CHANGE ORDER

Project: Woodland High School Project No.: 1119.00-12
 Architect: McGranahan Architects Change Order No.: 1
 Contractor: Skanska USA Building, Inc. Date: January 9, 2014

CHANGE ORDER PROPOSAL: 001

CHANGE ORDER PROPOSAL: 002R1

ASK-097

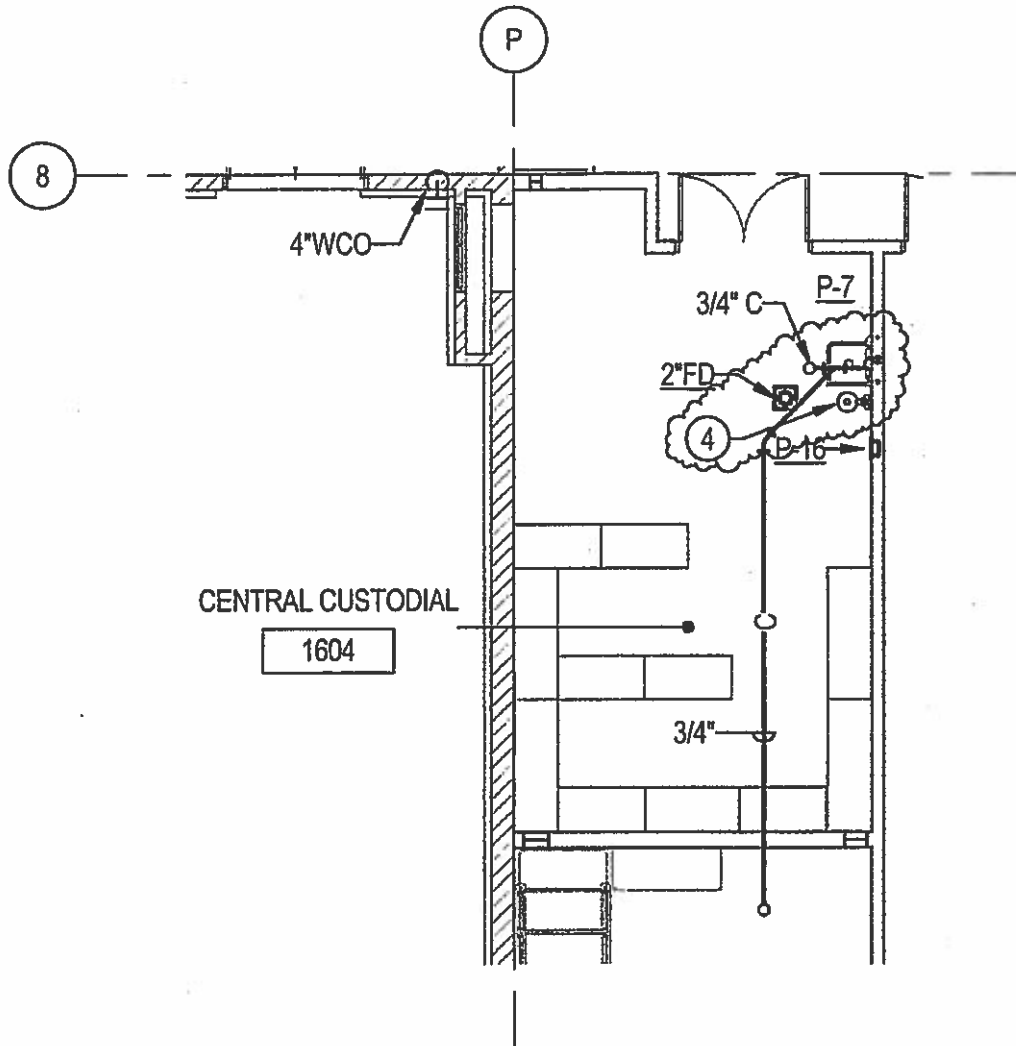
- 1. Add an emergency eyewash at Central Custodial 1604.
- 2. The eyewash will drain into the adjacent mop sink.

MSK - 065

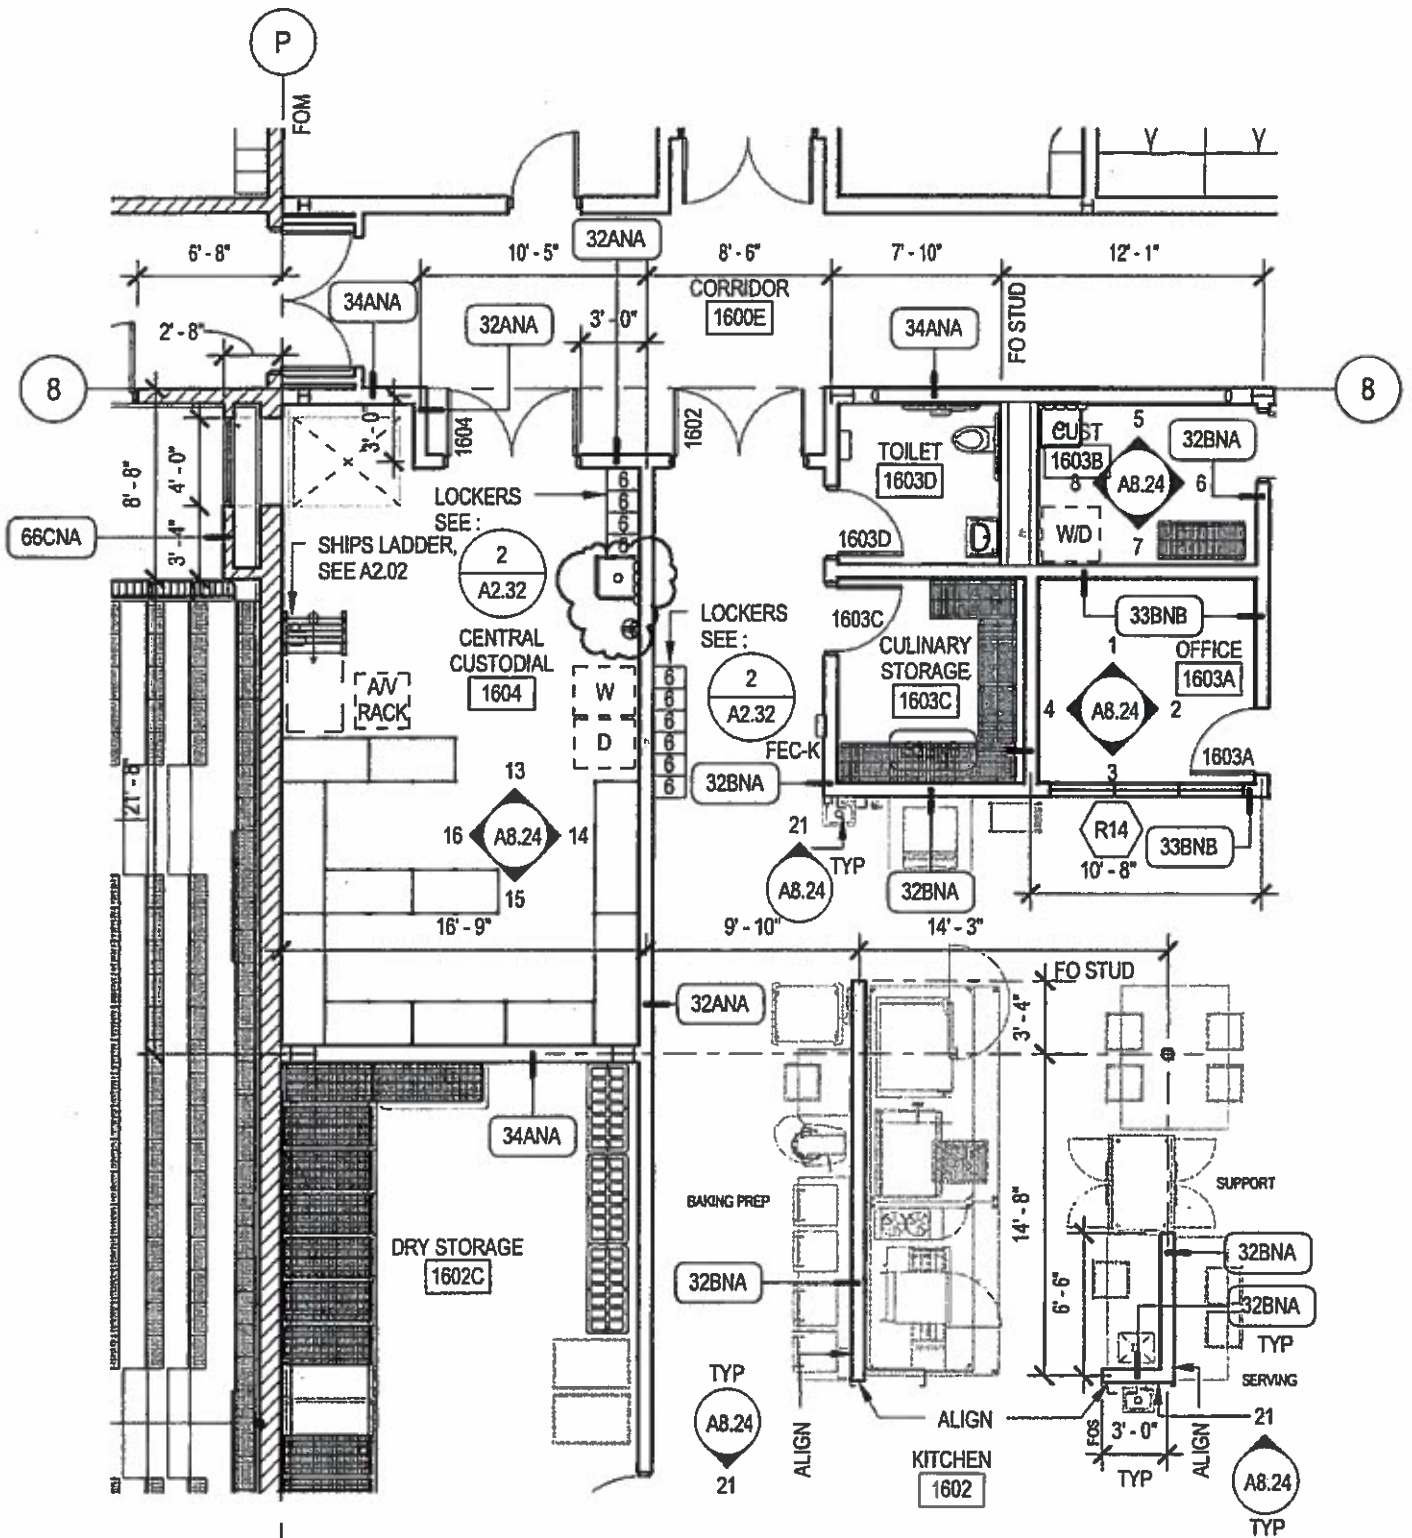
- 4 EMERGENCY EYEWASH, HAWS MODEL 7260B - 7270B. PROVIDE 1/2" HOT AND COLD WATER CONNECTION AND DRAIN EYEWASH INTO MOP SINK WITH 6" AIR GAP. PROVIDE WITH OPTIONAL TEMPERED WATER BLENDING SYSTEM MODEL TWBS.EWE. PROVIDE 1' X 1' WALL MOUNTED PANEL ABOVE EYEWASH TO ACCESS THERMOSTATIC MIXING VALVE. RELOCATE MOP SINK (P-7) 1' - 10" NORTH AS INDICATED.

ASK-098

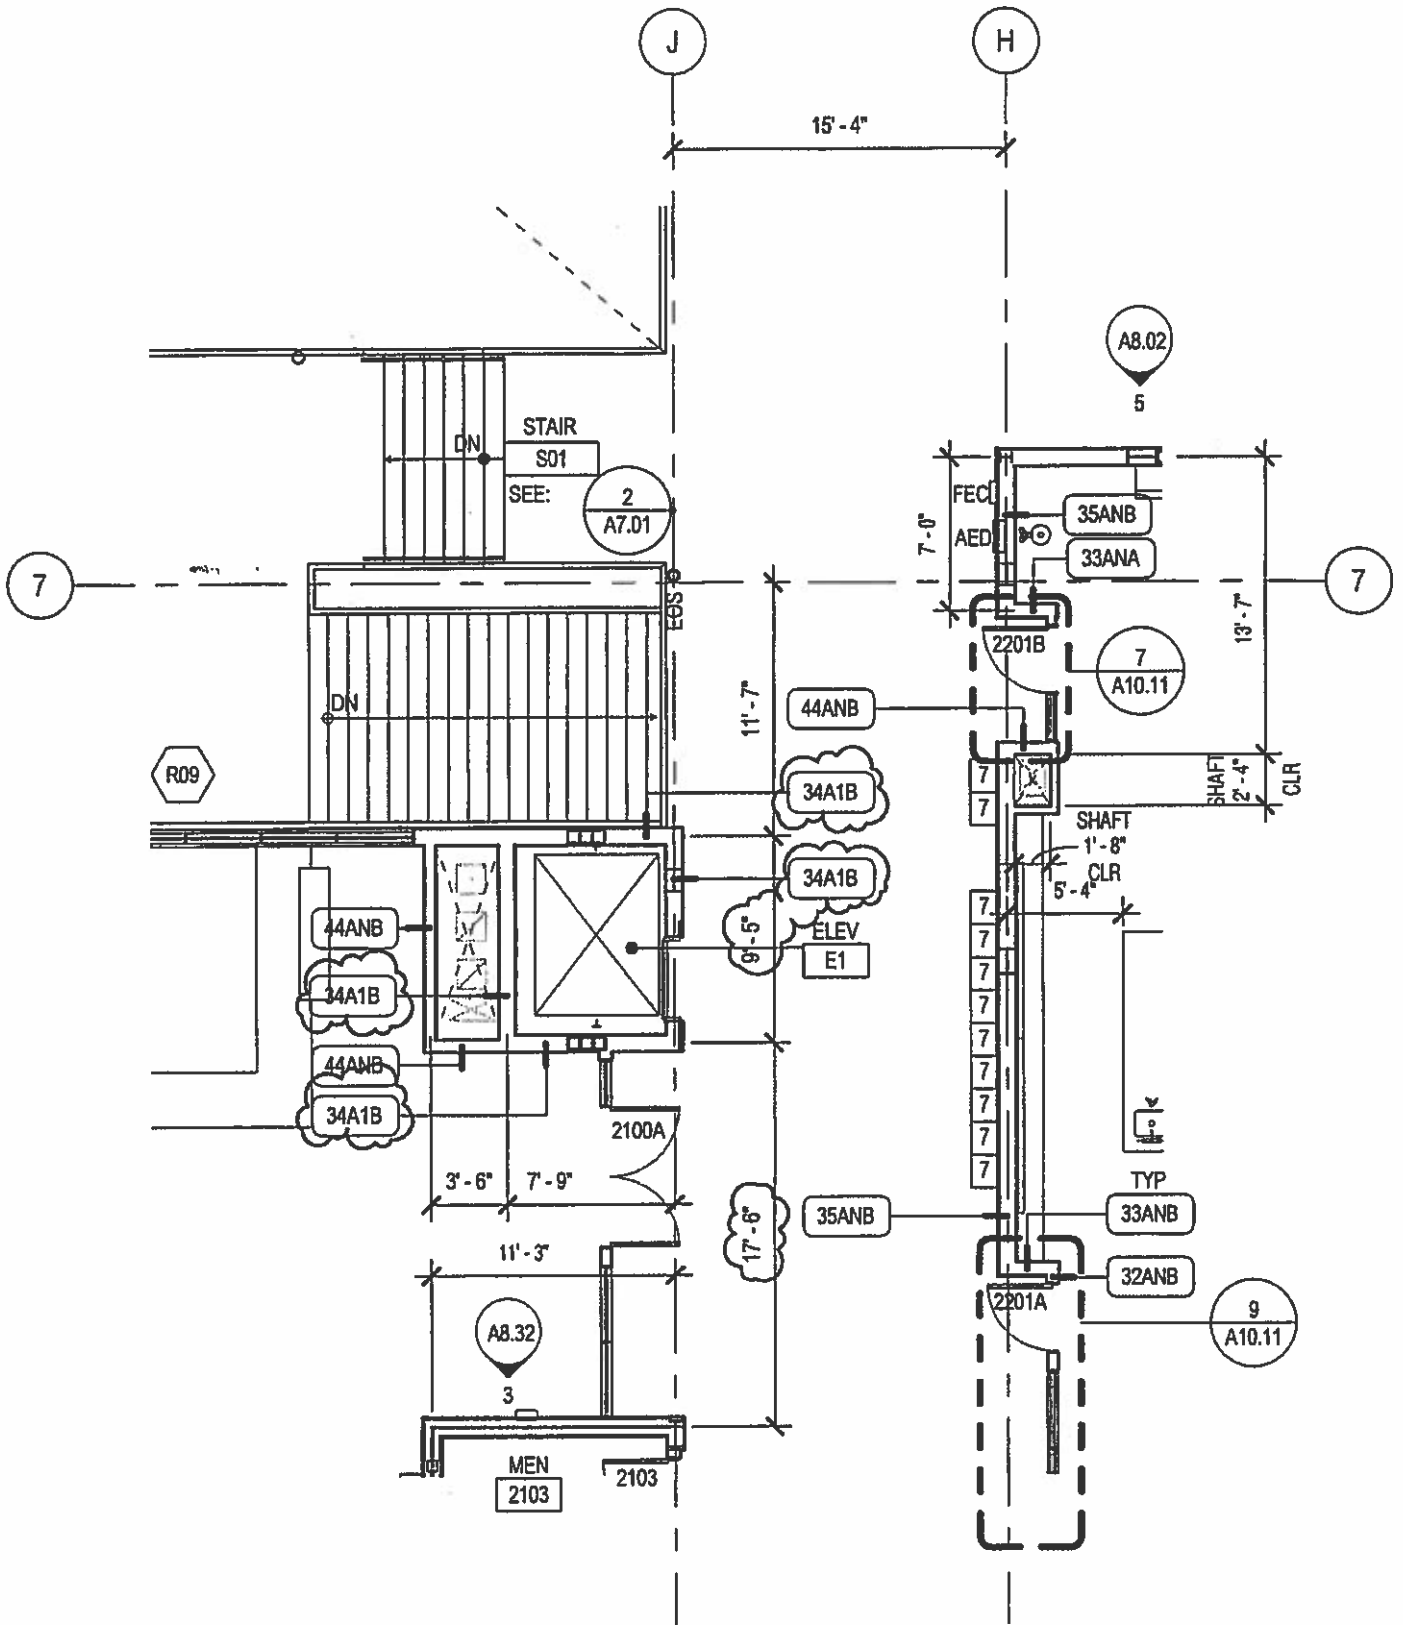
- 1. Change the elevator capacity from 3,500 lbs to 3,000 lbs.
- 2. Change the elevator shaft wall type from 50A1B to 34A1B.
- 2. Change the framing at the elevator jambs per the attached sketches.

ASK-101

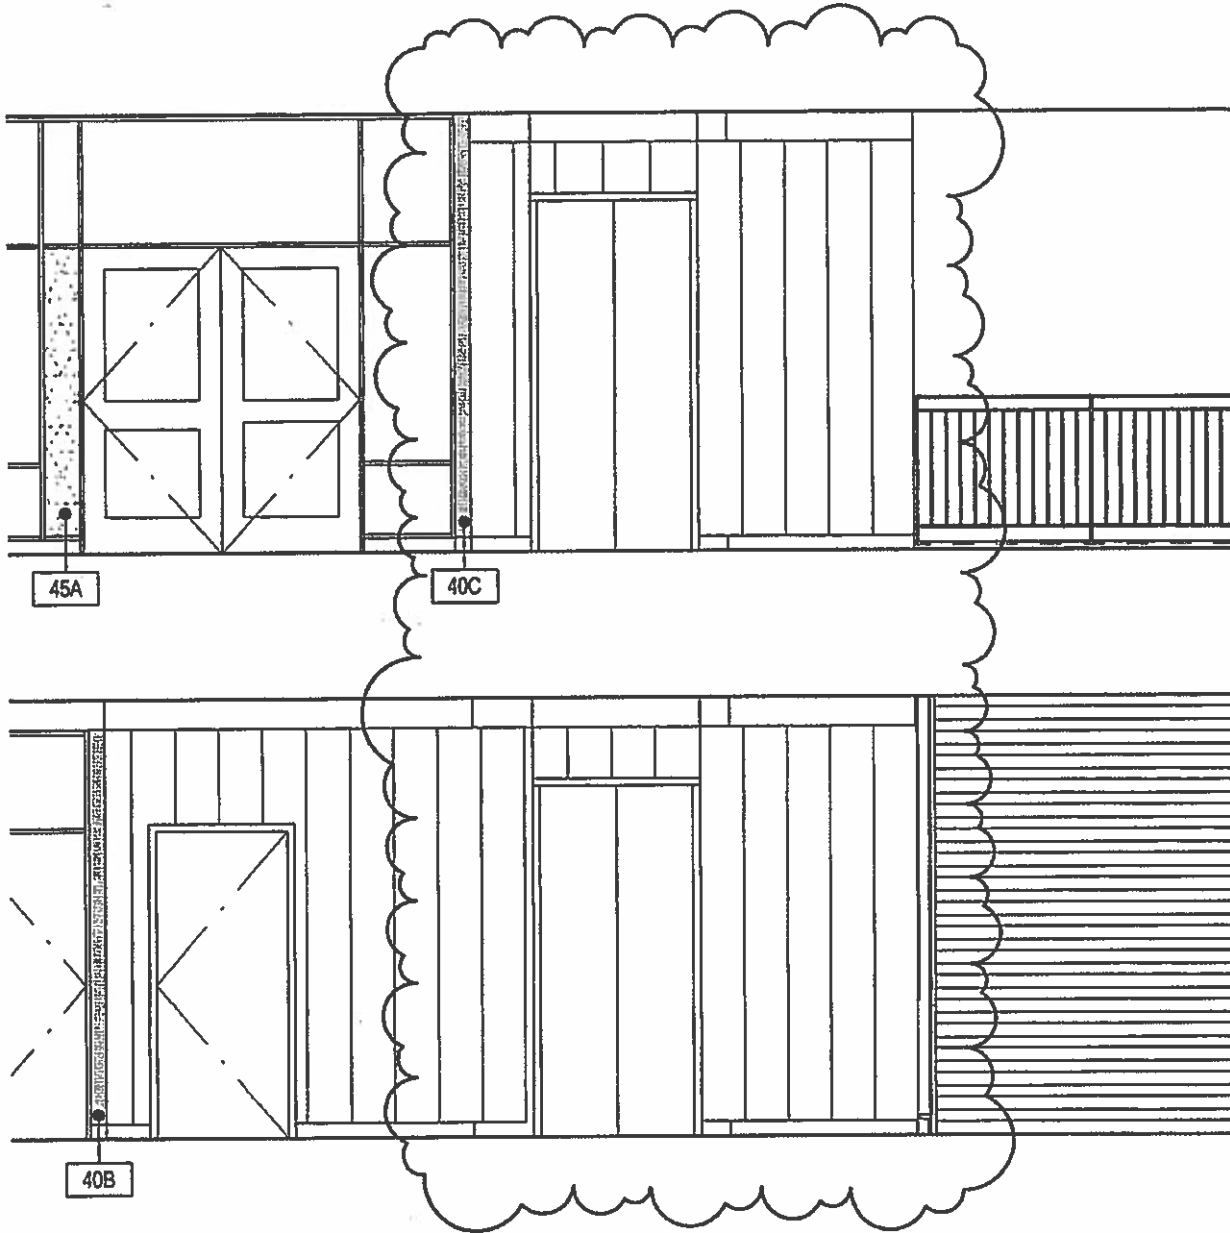
Scope: The wall type at Elevator E1 is changed from a shaftwall assembly to a standard stud framed wall and a wall off-set furring condition is added at the perimeter of the elevator door frames. There is added labor for hanging sheetrock from a scaffold at the interior of the elevator shaft and added labor and materials for the off-set wall condition (shown by detail ASK-101).
